Tollgate Acres I & II

Bozrah, Connecticut

REPORT

Review Date: MAY 6, 1986

WATERSHED BOUNDARY

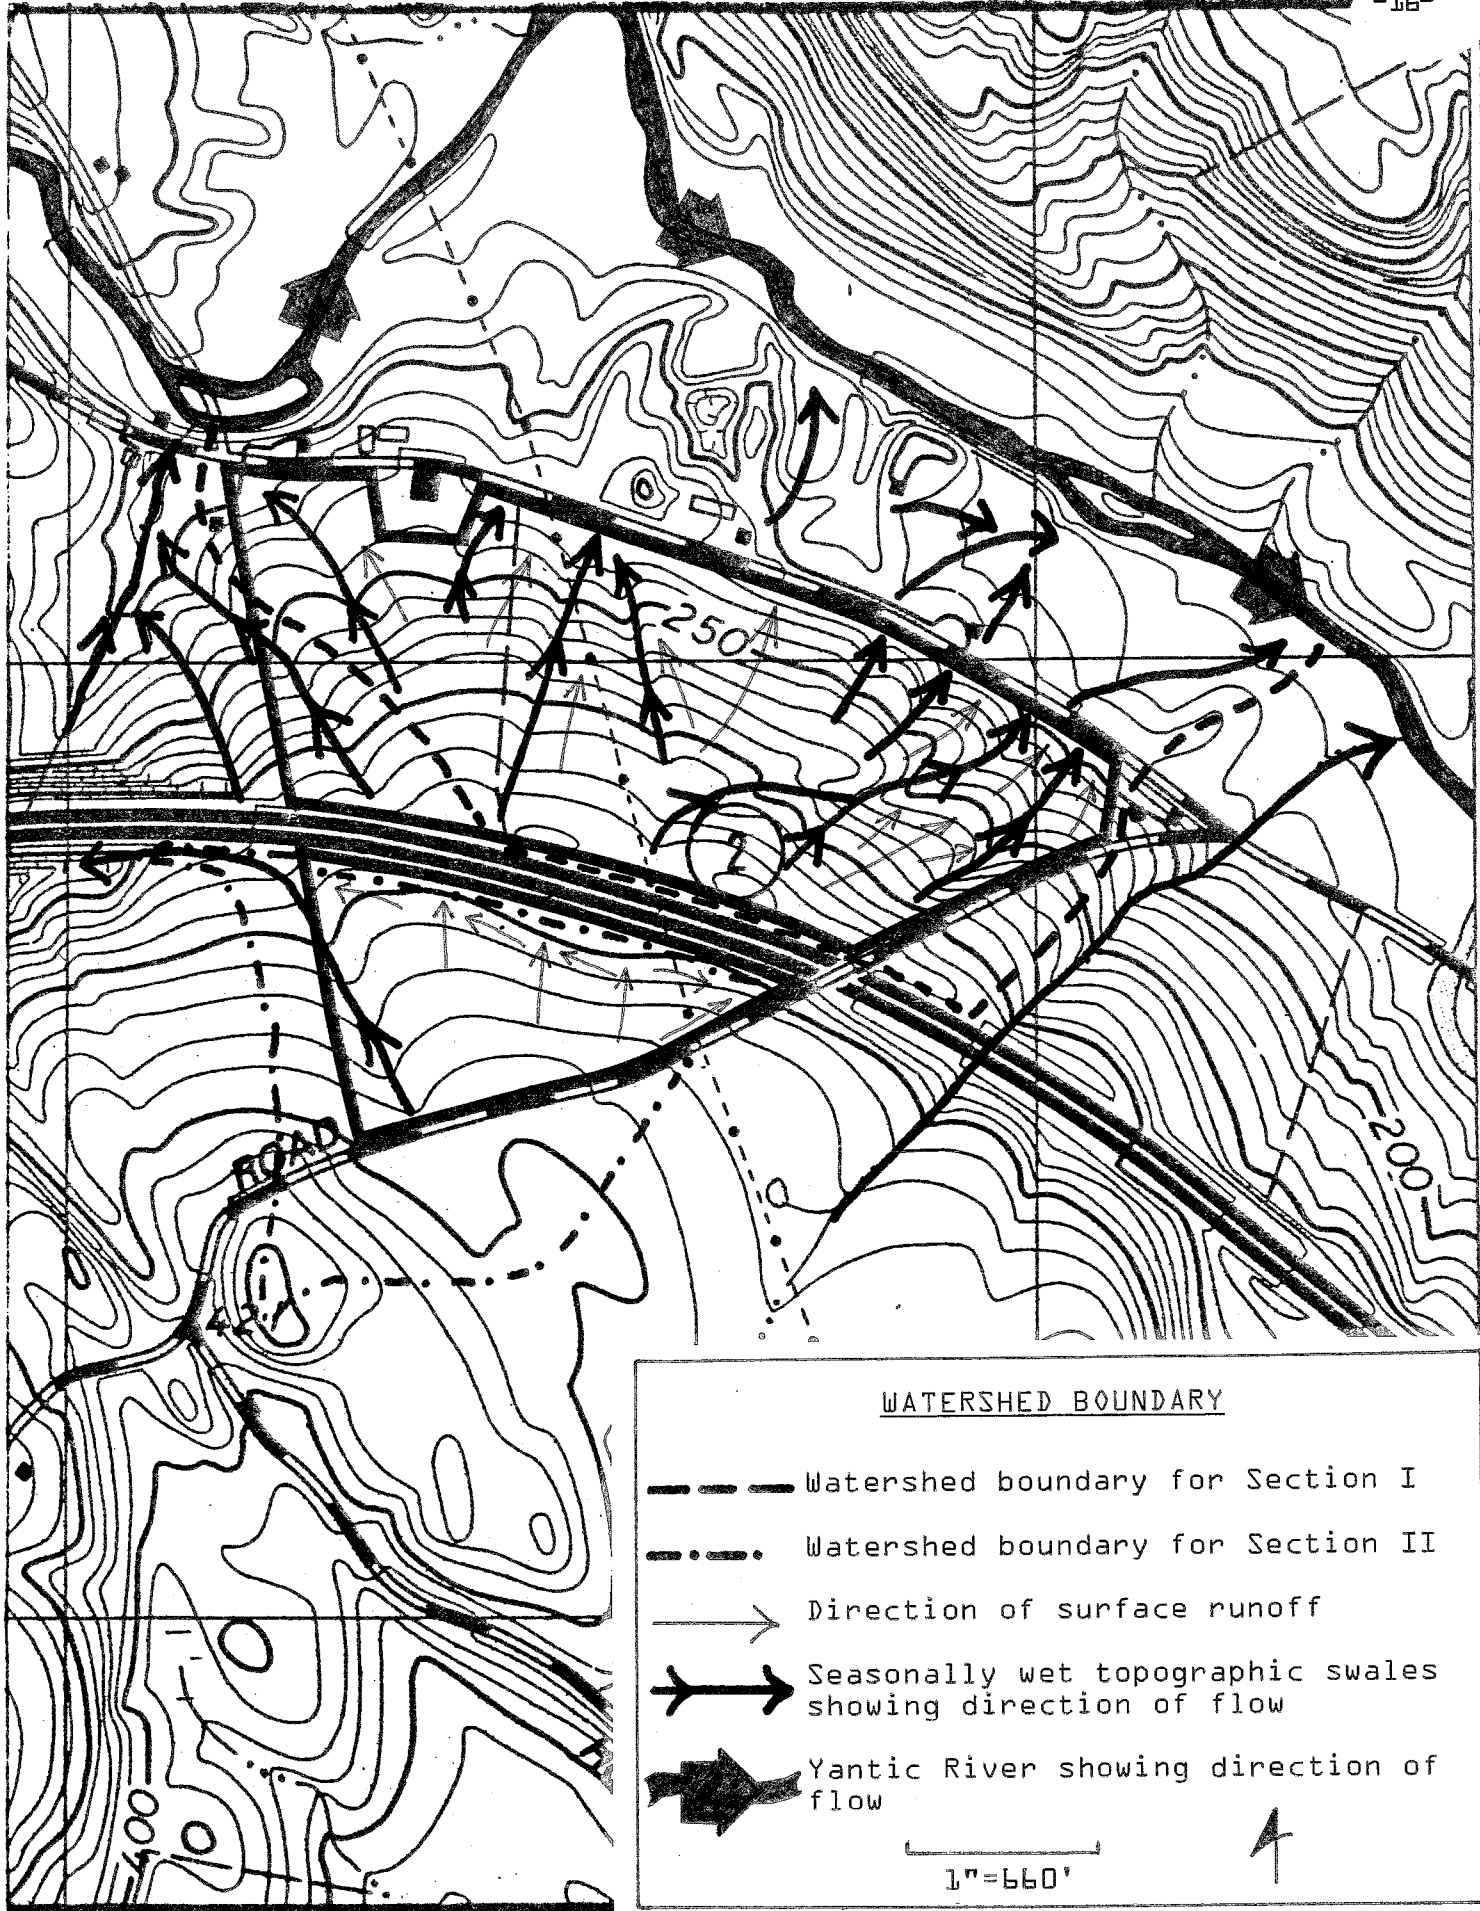
Development of Section I as planned would be expected to cause some increases in runoff. These increases would arise mainly from the creation of impervious surfaces such as roof tops, driveways, patios, etc., over otherwise pervious soils. Because of the large drainage area of Yantic River, there should be no noticeable impact on the river's normal flow rates. In addition, the density of the proposed subdivision is not that high. Nevertheless, as a matter of policy, the applicant's engineer should formulate a stormwater management plan, which includes pre and post-development runoff calculations. Once the project engineer compiles this information, it can then be determined whether or not post-development runoff increases will require stormwater detention. Close examination of the pipes passing under Route 608 is warranted to determine if they will be able to handle post-development flows without causing any flooding problems or ice problems during winter months on the road.

The driveways into the lots fronting Route 608 may become a source of pollution, however. Water flowing down the driveways during rainy periods or snow melt could carry sand, salt, oils and other debris ultimately into the river. Because some of the lots in this area will be sharing driveways this should help reduce the risk of pollutions.

It seems likely that the major risk from the driveways would be sand. Although salt and oil may be introduced into the streamcourses feeding Yantic River, the quantities would probably be small and the contaminants would be likely to move through the tributary and river system. Because driveways would be constructed on moderate to steep slopes, sand will be washed quickly

down the slope, across the road {Route 608} and into the streamcourse leading to Yantic River. This would lead to the accumulation of sand in tributaries to Yantic River and Yantic River itself. Perhaps some type of sediment trap could be designed for the end of driveways to prevent sand from crossing Route 608. The design specifications for this potential erosion sediment control measure should be incorporated into the stormwater management or erosion and sediment control plan.

LOT LAYOUT AND DRIVEWAYS*

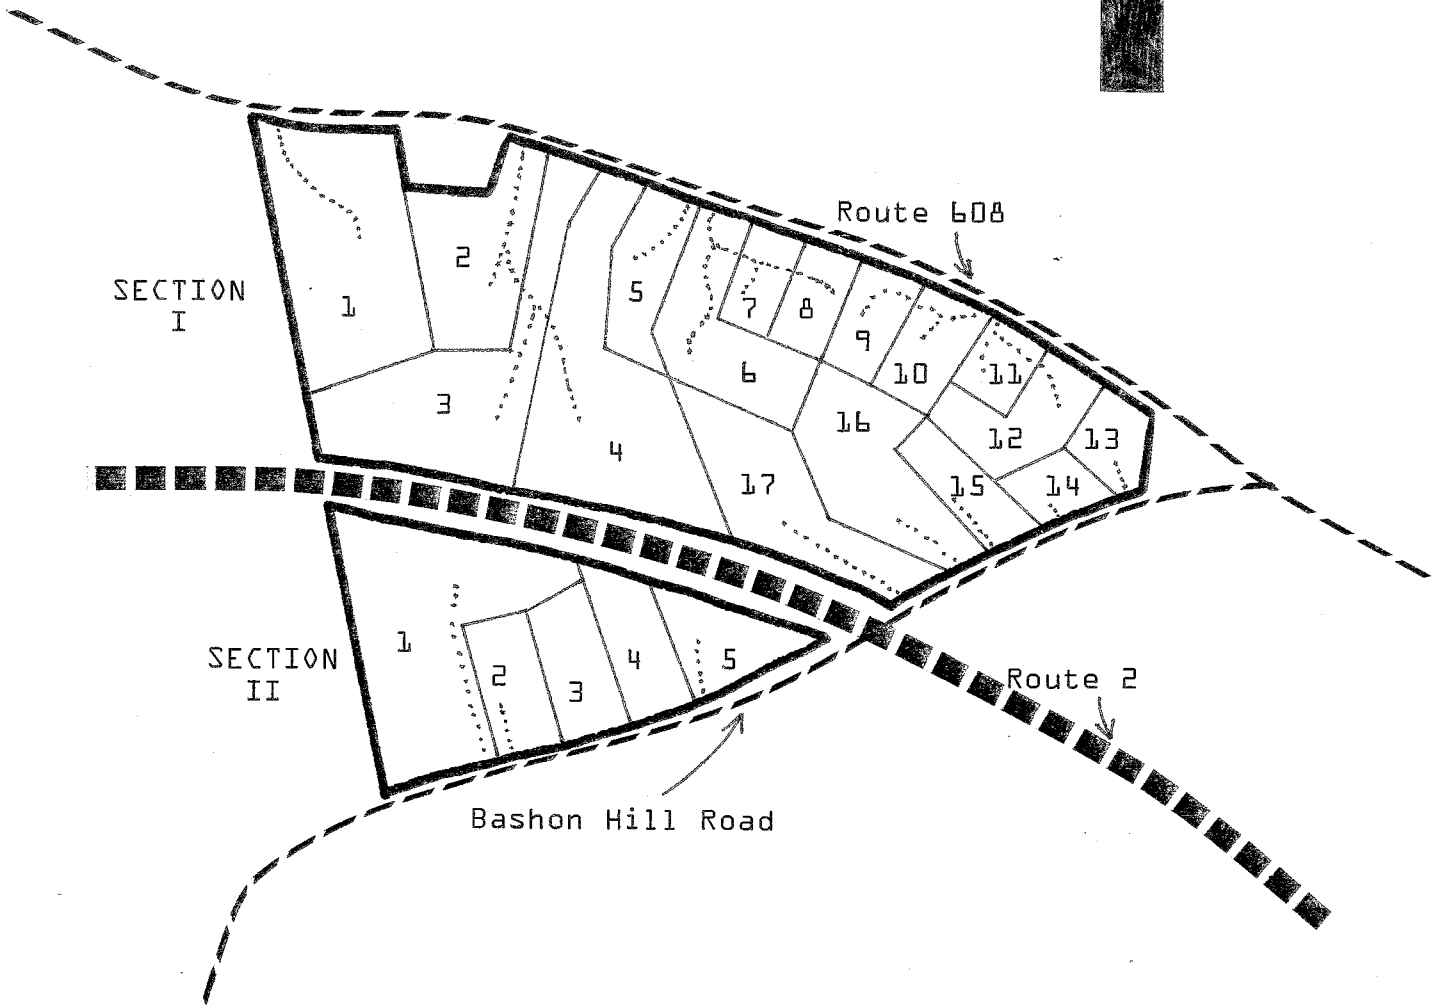
The principal access concerns about this subdivision are centered on the Tollgate Acres Section I proposal, that is, the subdivision which fronts on Route 608 and Bashon Hill Road. Here, the developer proposes to have 12 lots gaining access from Route 608 via a series of driveways. One driveway serves Lot 1; and a second driveway serves Lots 2, 3, and 4; a third serves Lot 5; a fourth Lots 6, 7, and 8; a fifth Lots 9 and 10; and a sixth, Lots 11 and 12. The remaining lots in the subdivision are served by individual driveways from Bashon Hill Road.

All of the driveways on Route 608 must cross the City of Norwich 30 inch water main which is located along the road frontage of the property.

Of these driveways, the most workable appears to be that serving Lots 2, 3, and 4. Here the grades from the highway into the property are relatively flat and the Norwich water line is located a sufficient distance to the north of the property line to permit ramping up to provide adequate cover over the water line. Here also the sight lines along the highway are relatively good.

At all the other driveway locations on Route 608, the water line is, according to the plan, about 25 feet from the front property line. It seems questionable whether or not there is adequate distance to properly grade the driveway in order to provide a relatively level place for a car to stand before entering the highway, and then having an acceptable slope and still be able to get over the water line. Also, while at all of these driveway locations adequate sight distances along the highway appear to be achievable, at the driveways serving Lots 5 through 12, it would seem necessary to cut down some large trees. Here, care would have to be taken so as not to disrupt the steep banks between the property and the road and thus cause an erosion problem. In summary, from the driveway serving Lot 5 eastward to Bashon Hill Road, vehicular access of any kind to the property appears difficult. This is not so along Bashon Hill Road or at the location of the proposed driveway serving Lots 2, 3, and 4.

In addition, there are obvious problems with this scheme in the provision of emergency services, and the questions of maintenance responsibility among the homeowners served by any given driveway.

While it is recognized that construction of a road or roads to Town standards would have an adverse effect on the rural character of the neighborhood, this consideration seems outweighed by the difficulty of access. It is suggested that a plan could be devised with most of the lots served by two {2} cul-de-sac public roads. One would connect with Route 608 at the proposed location of the driveway for Lots 2, 3, and 4, and would serve all lots west of the Connecticut Light and Power right-of-way with the possible exception of Lot 1. The other cul-de-sac would enter the property from Bashon Hill Road. Alternatively, a road could be constructed connecting the two access points.
